Addendum No. 01

Subject: Edmonds Classroom Modernization Project

Location: Franklin S. Edmonds Elementary School

This Addendum, *dated February 26, 2019,* shall modify and become part of the Contract Documents for the work of this project. Any items not mentioned herein, or affected by, shall be performed strictly in accordance with the original documents.

THE ABOVE CHANGES TO THE CASEWORK SCHEDULE ARE SHOWN IN THE REVISED A300-Rev 1 DRAWING ISSUED WITH THIS ADDENDUM.

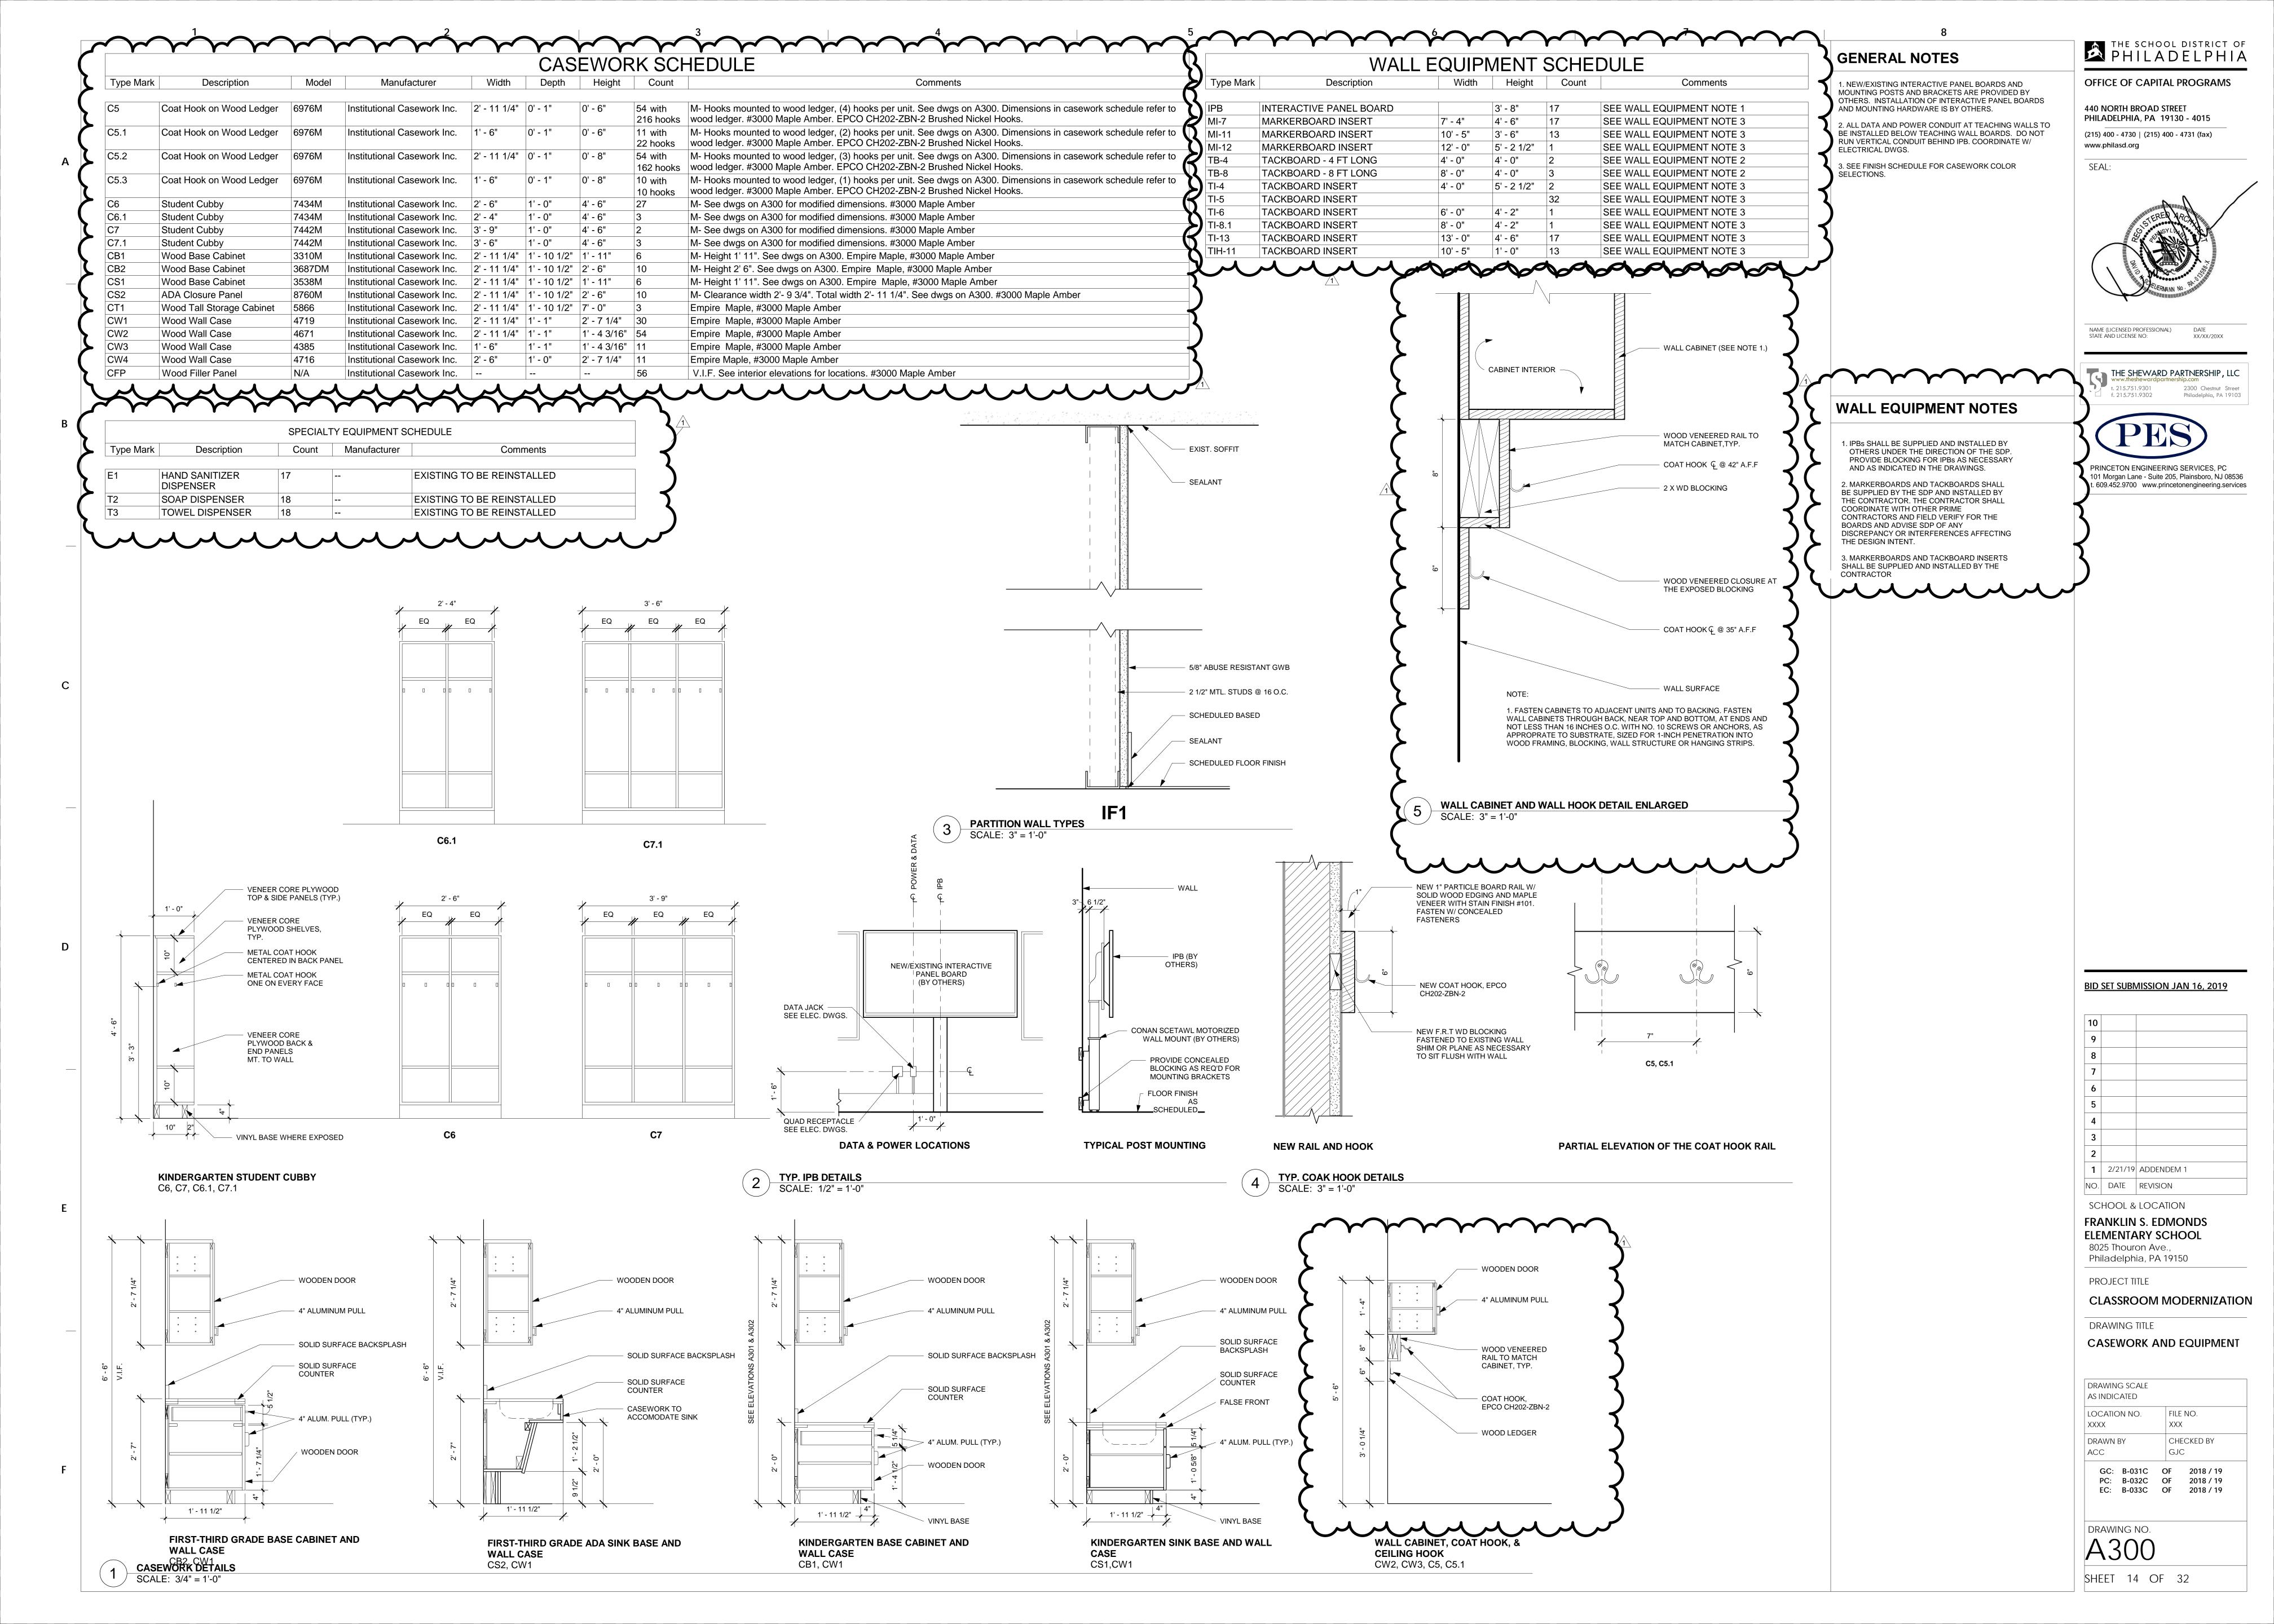
a. A300: CASEWORK SCHEDULE:

The Casework Schedule is revised as follows:

THE BASIS OF DESIGN CABINET SHALL BE CAMPBELL RHEA "EMPIRE" Full Flush Overlay with Solid Wood Edging. DELETE REFERENCES TO "SIGNATURE" STYLE CABINETS.

THE BASIS OF DESIGN MODEL FOR CABINET TYPE CT1 IS CHANGED TO 5866, 35-1/4" (W) X 84" (H) X 22-1/2" (D)

THE BASIS OF DESIGN MODEL FOR CABINET TYPE CT2 IS CHANGED TO 5866, 35-1/4" (W) X 84" (H) X 22-1/2" (D)

THE QUANTITIES AND TYPES OF WALL RAILS AND COAT HOOKS ARE REVISED

b. A300: WALL EQUIPMENT SCHEDULE:

The Wall Equipment Schedule is revised as follows:

DELETE ALL THE NOTES UNDER THE "COMMENTS" COLUMN OF THE SCHEDULE.

Work in connection with Display Boards shall be conducted as follows:

IPBs SHALL BE SUPPLIED AND INSTALLED BY OTHERS UNDER THE DIRECTION OF THE SDP. PROVIDE BLOCKING FOR IPBs AS NECESSARY AND AS INDICATED IN THE DRAWINGS.

MARKERBOARDS AND TACKBOARDS SHALL BE SUPPLIED BY THE SDP AND INSTALLED BY THE CONTRACTOR. THE CONTRACTOR SHALL COORDINATE WITH OTHER PRIME CONTRACTORS AND FIELD VERIFY FOR THE BOARDS AND ADVISE SDP OF ANY DISCREPANCY OR INTERFERENCES AFFECTING THE DESIGN INTENT.

MARKERBOARD AND TACKBOARD INSERTS SHALL BE SUPPLIED AND INSTALLED BY THE CONTRACTOR

c. A300: CASEWORK DETAIL:

Delete "WALL CABINET, WALL HOOK, & CEILING HOOK" detail

Add "WALL CABINET & WALL HOOK DETAIL" shown on A300-Rev1 issued with this Addendum

A302

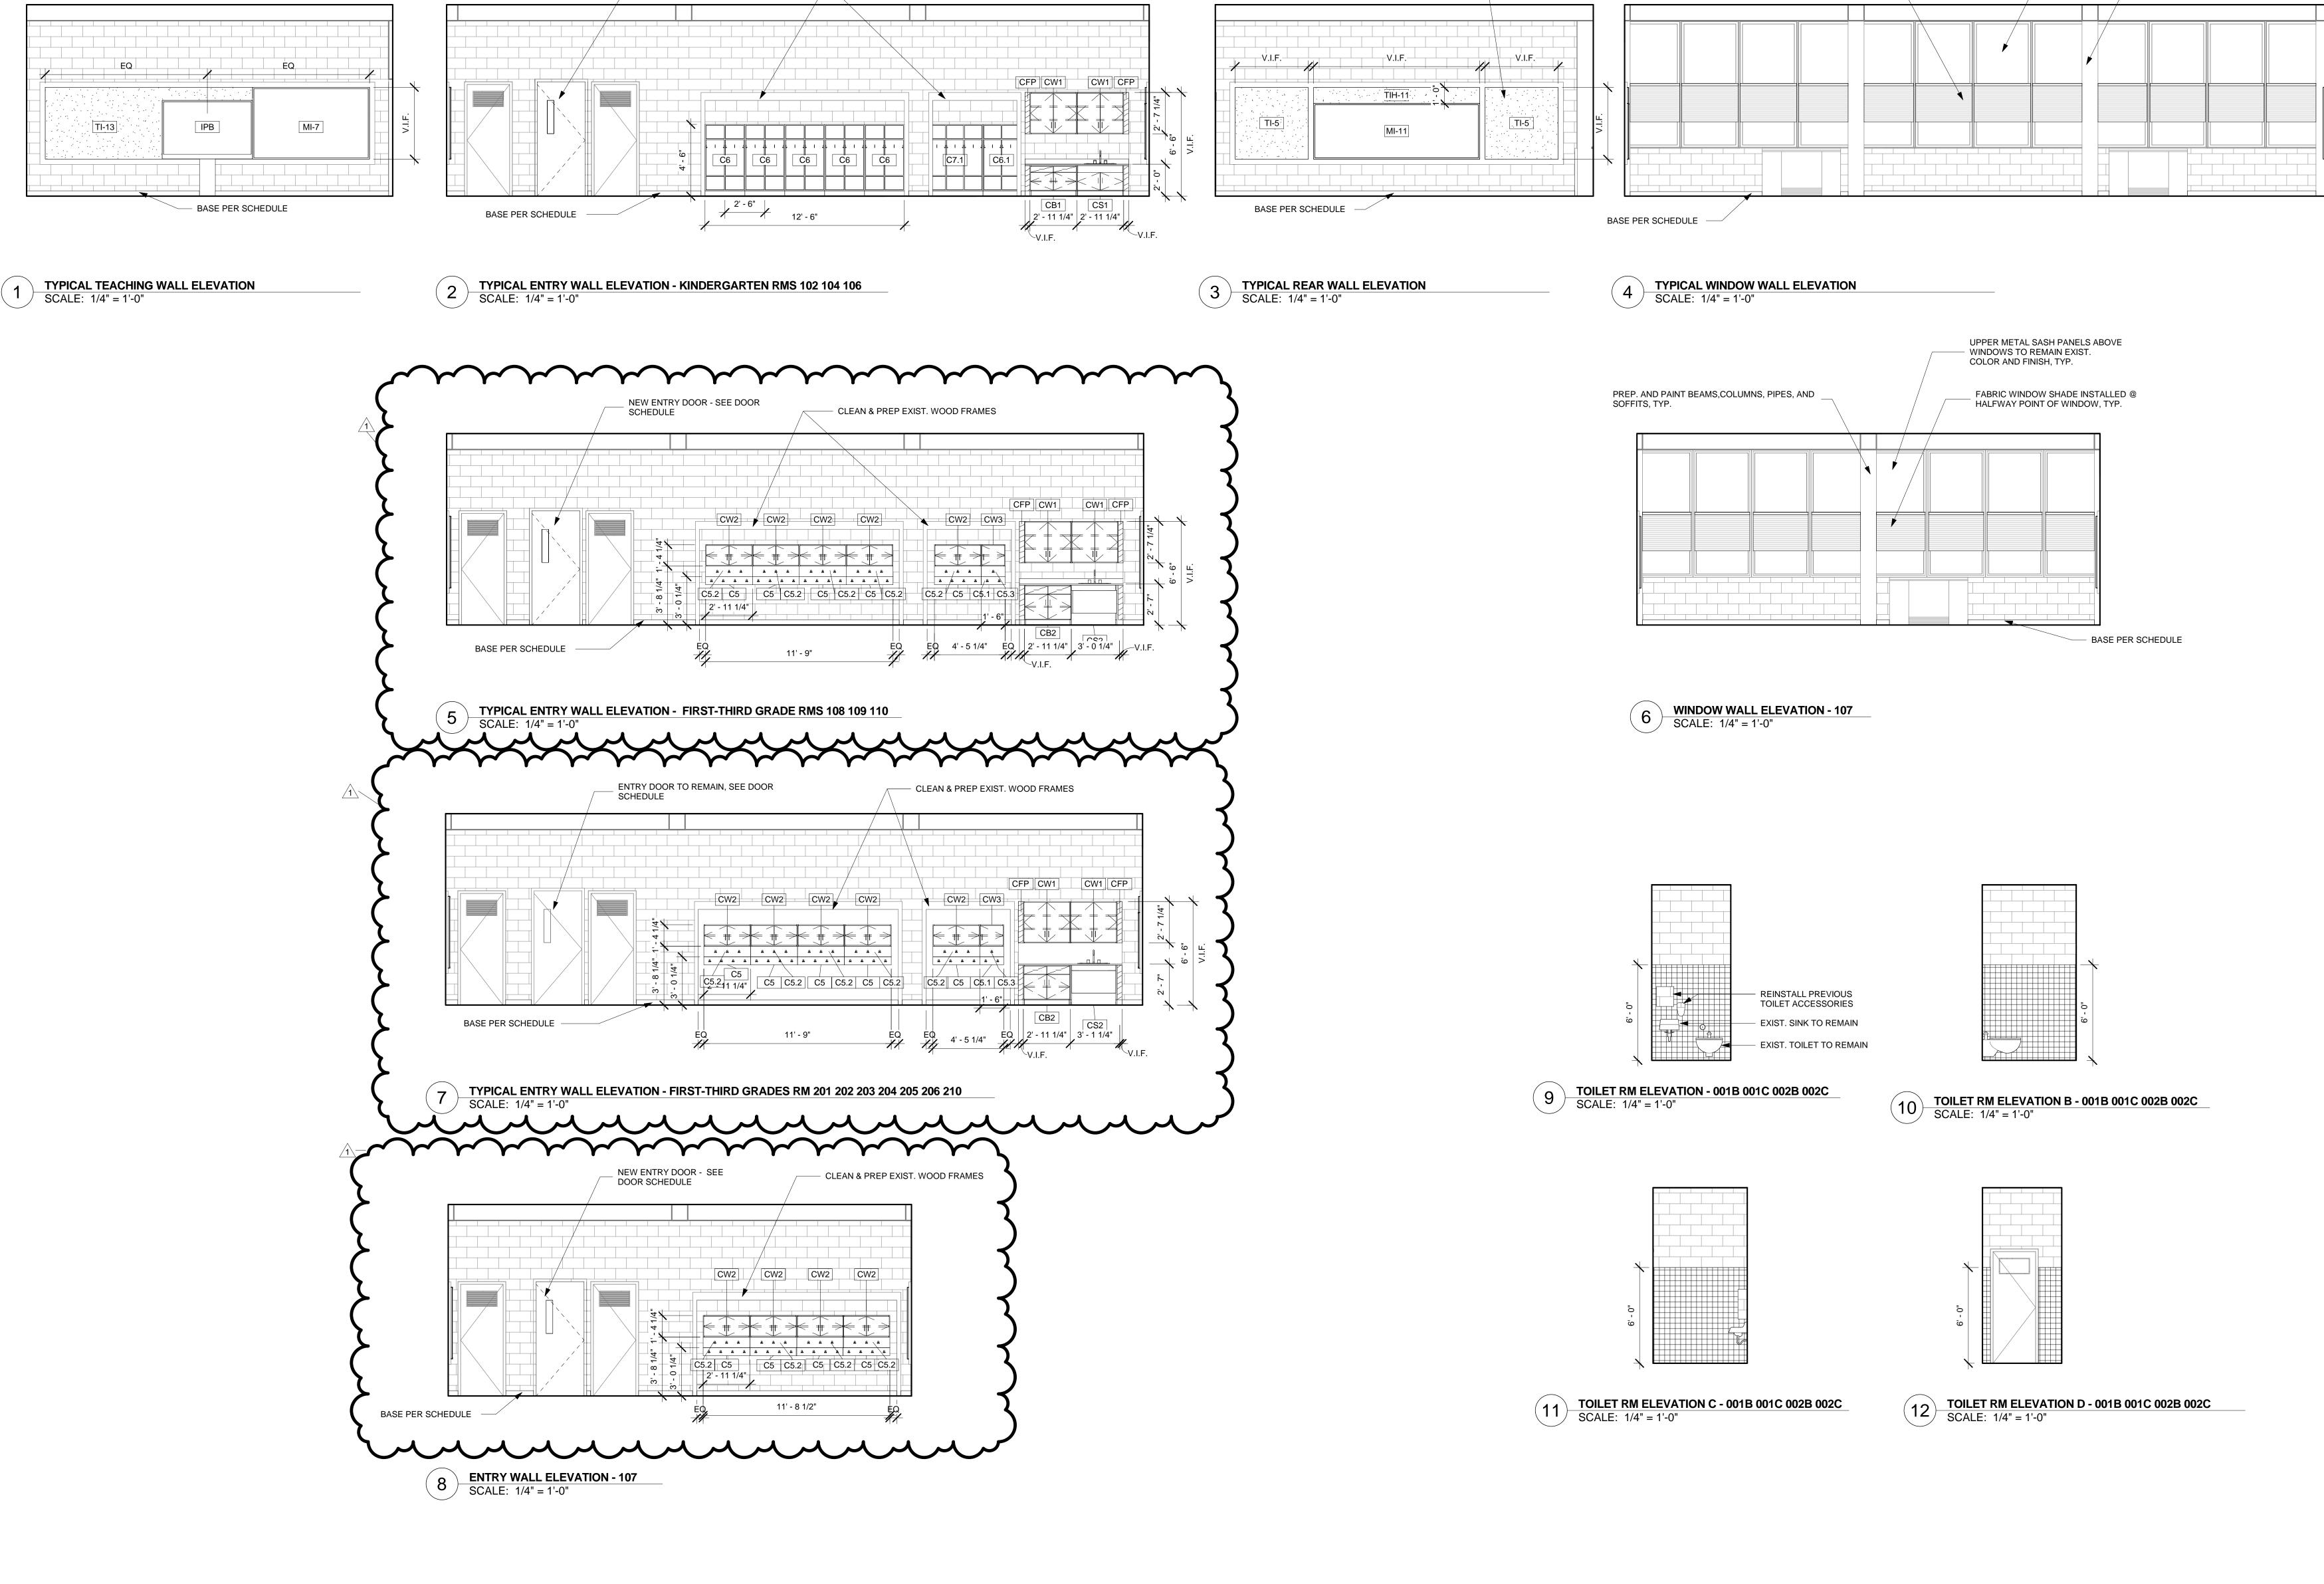
d. A302: INTERIOR ELEVATIONS

DETAILS 5, 7, 8 ARE REVISED, SEE A302 REV 1 ISSUED WITH THIS ADDENDUM.
